Fwd: Matthews Festival - Rezoning Petition 2016-650

On your Monday December 12th Board Agenda is a decision on Rezoning Petition No. 2016-650 by Ziff Properties for Matthews Festival.

Changes to the Petition to address comments and issues:

Matthews Festival
US Hwy 74
Matthews, NC

RZ-3

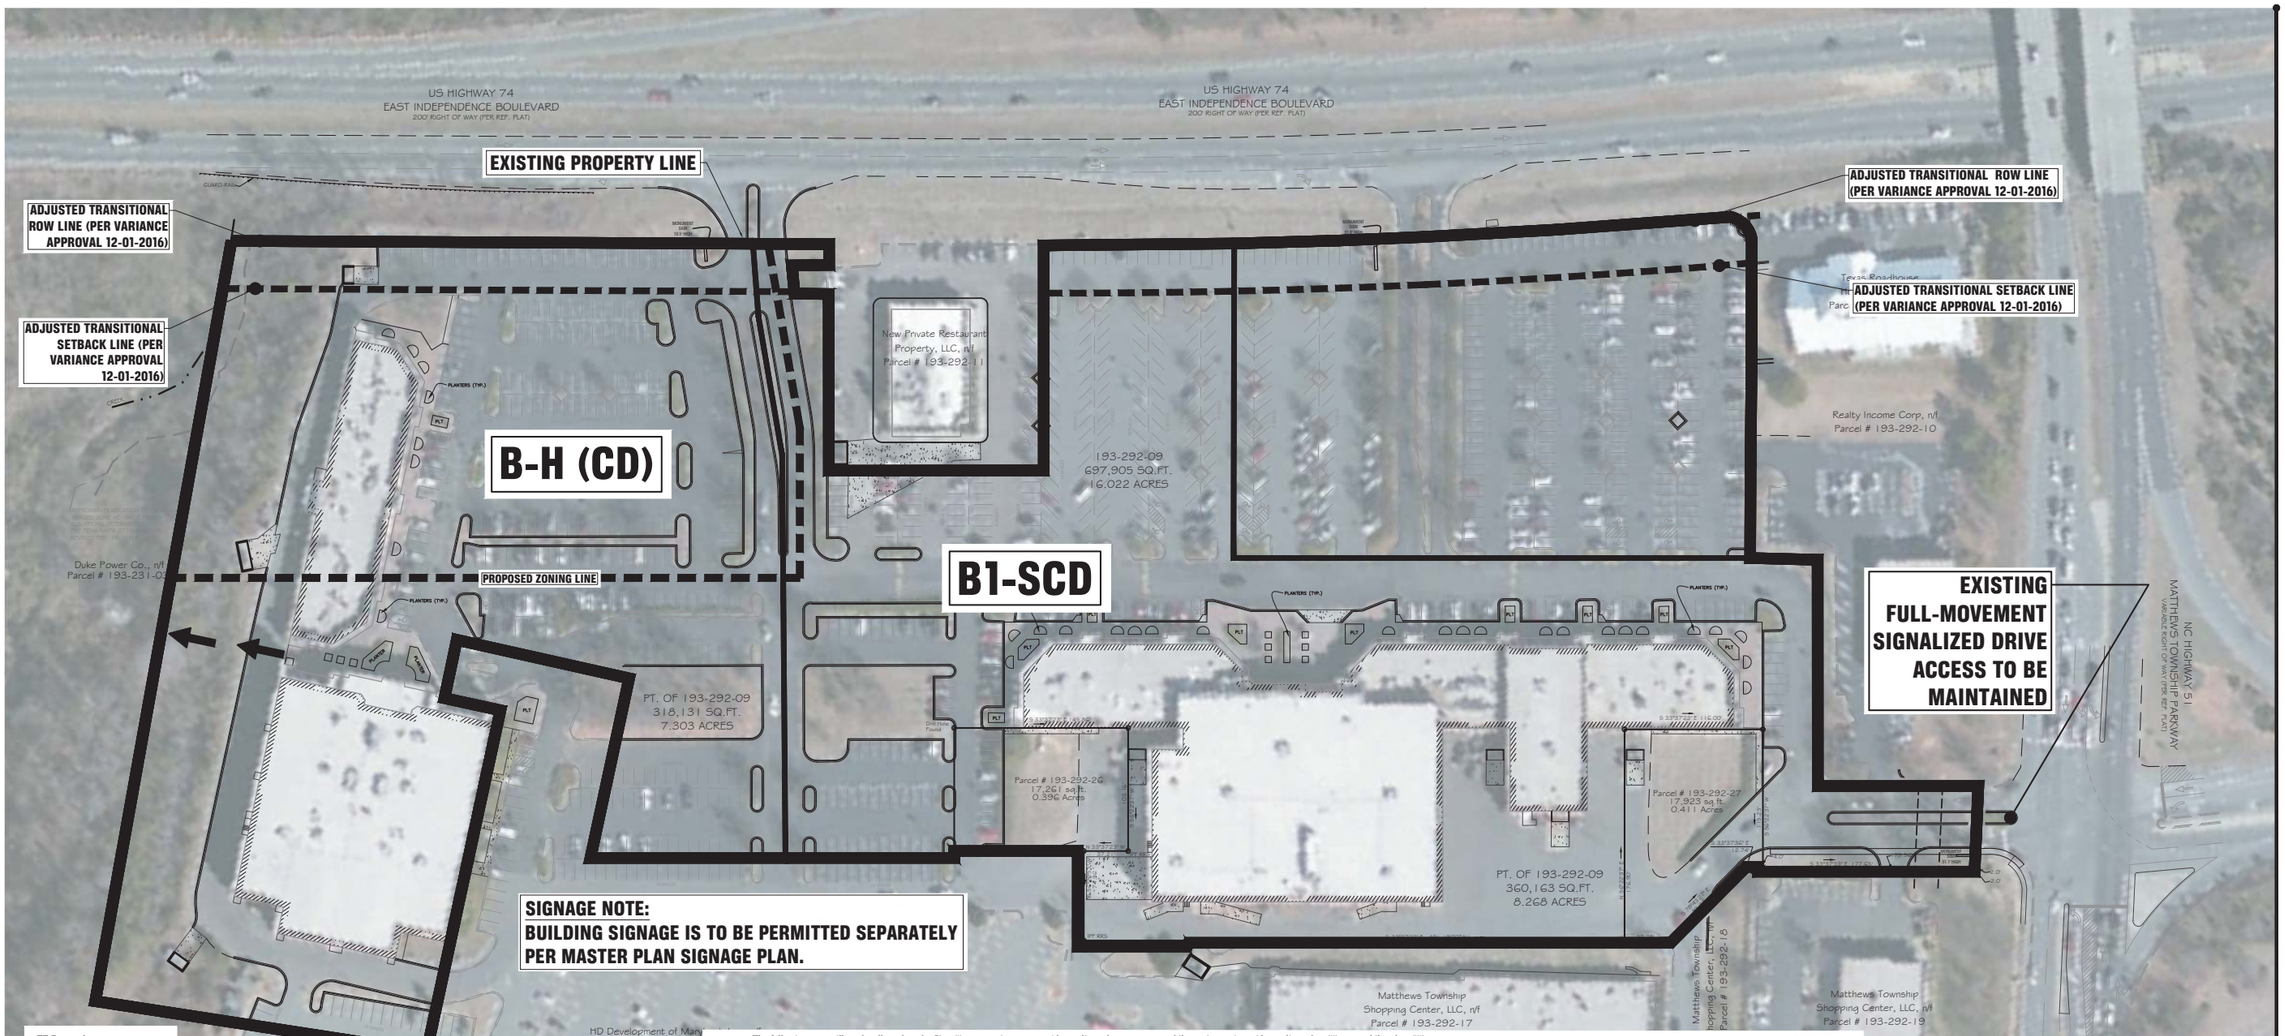
- The proposed zoning line for the B-H(CD) zoning district has been reduced to include only the portion of Development Area # 3 where the proposed BJ's Restaurant & Brewhouse and associated parking will be located.

- The Petitioner will also add the following note regarding a possible change to the egress and ingress from Independence Boulevard if NCDOT does not issue a driveway permit for the relocated driveway. The note will read as follows:

c. If NCDOT does not issue a driveway permit for the relocated driveway to Independence Boulevard the Petitioner will modify the layout of the internal parking areas to reflect changes to the proposed ingress and egress from the Site. The Matthews Planning Director will review the revised internal parking circulation per the requirements of Section 155.401.5 of the Ordinance.

DRAWN	JPM
DESIGN	JPM
CHECKED	
DATE	November 2016
SCALE	1" = 50' - 0"
JOB NO.	16072
SHEET	L1.0

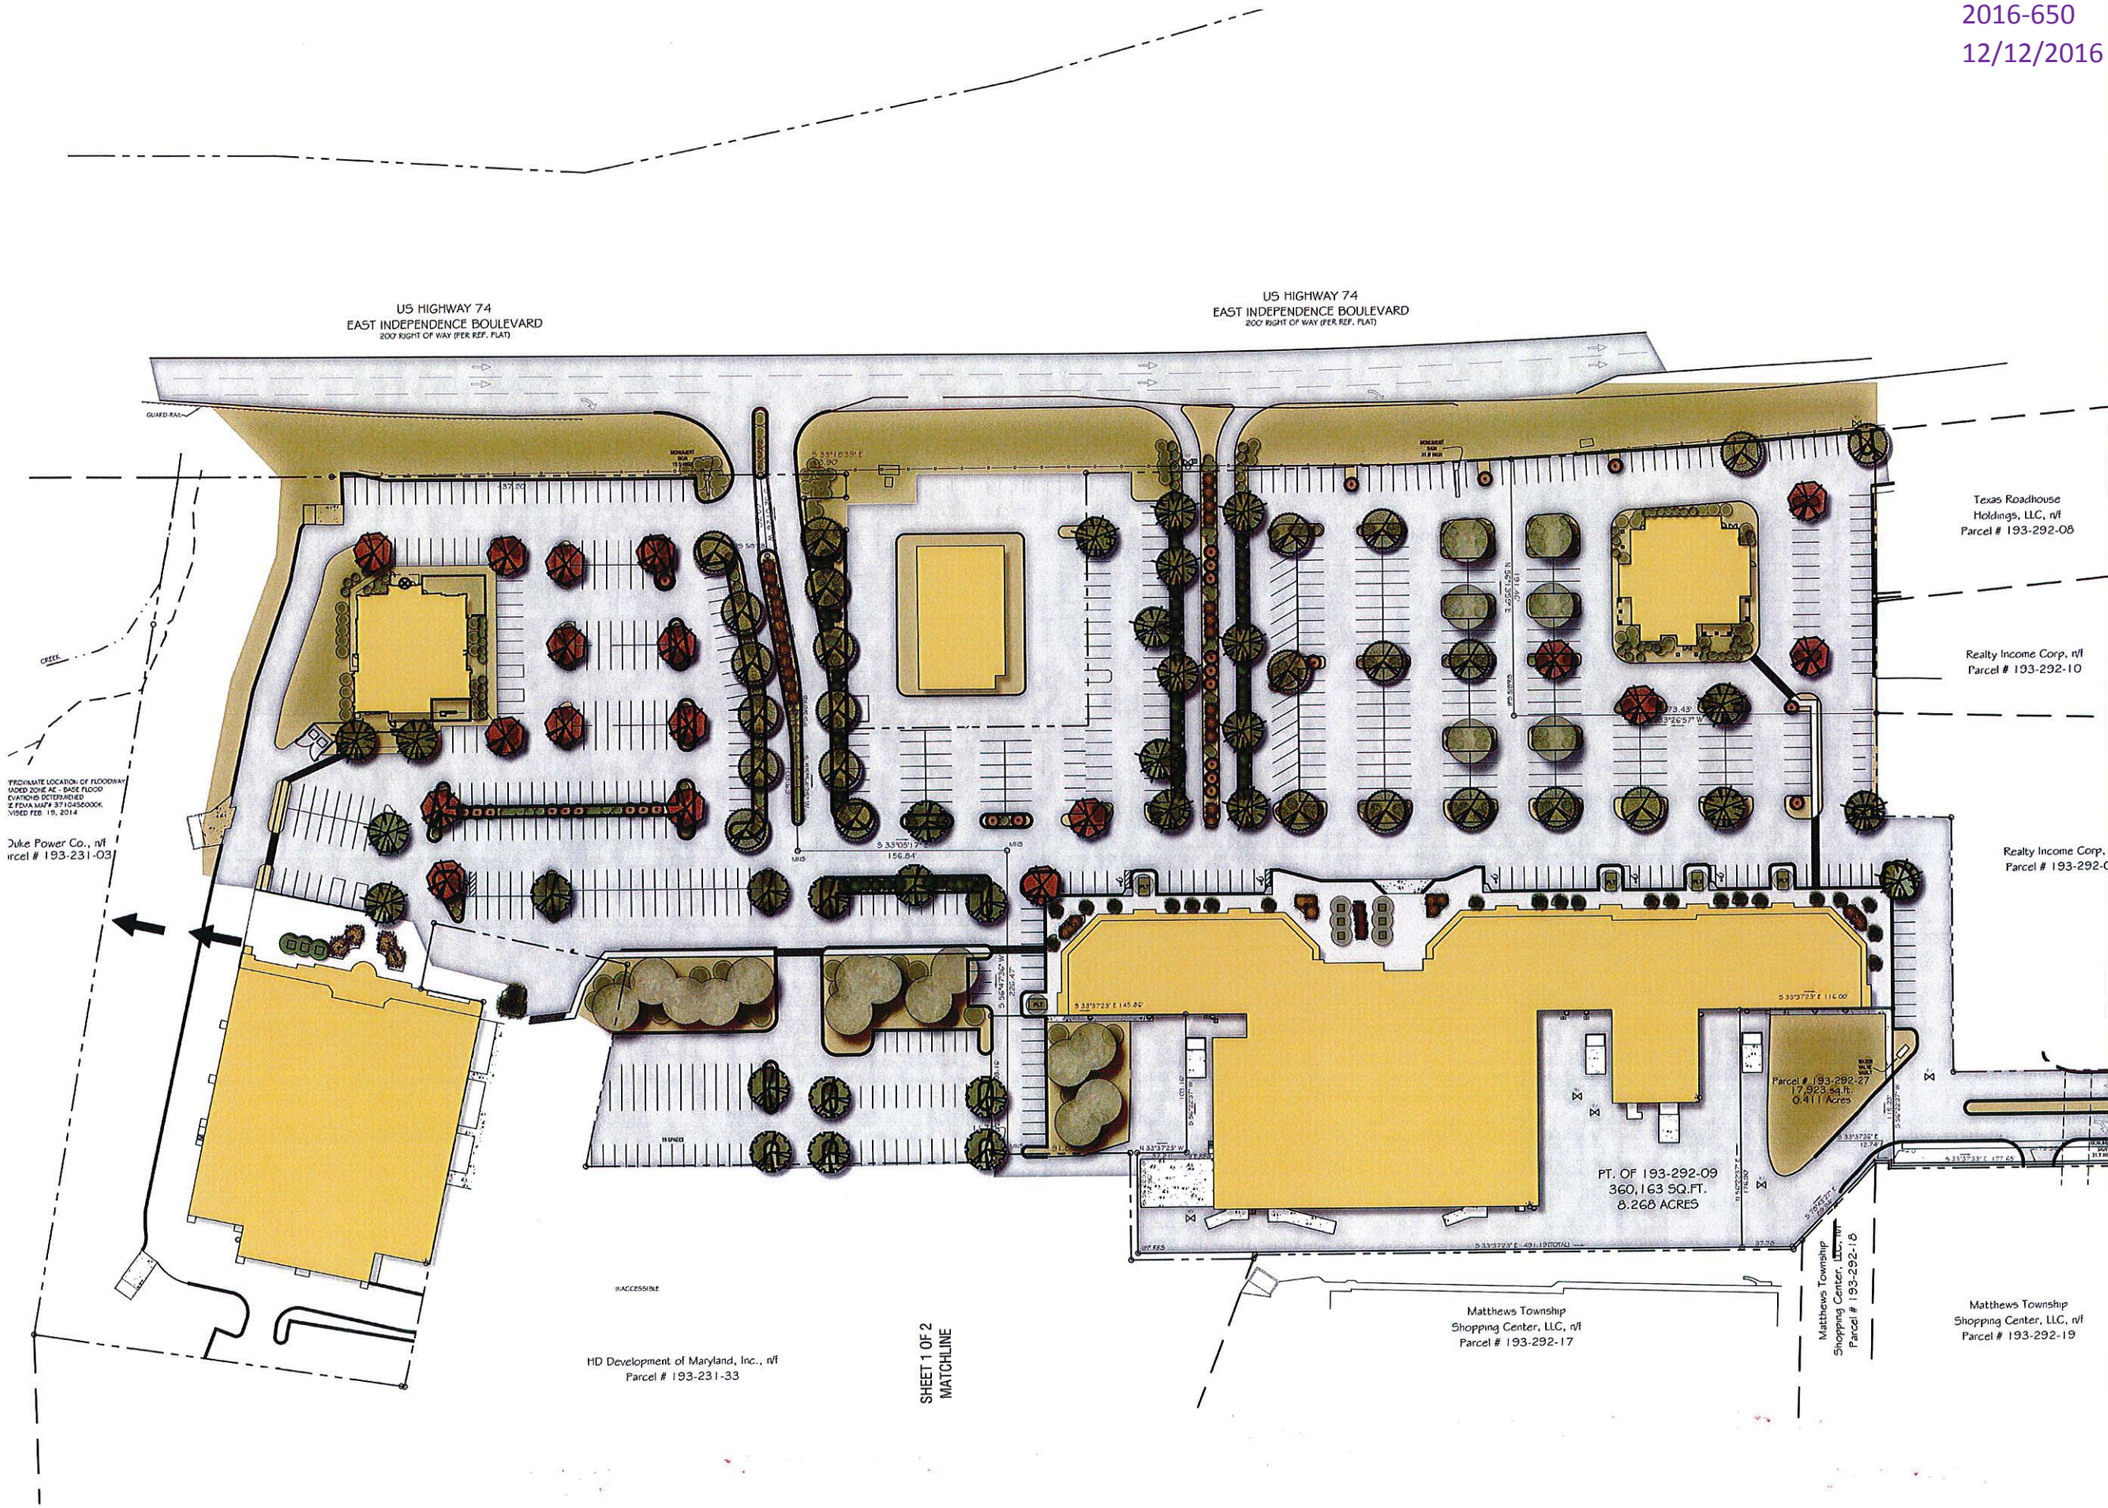
- Add a proposed landscape plan for the Site that indicates proposed tree planting areas as well as existing trees on the Site that will be preserved.

e. A minimum of six (6) of the existing trees located in landscape islands of the existing driveway to Independence Boulevard that is to be closed will be preserved as generally depicted on the Rezoning Plan.
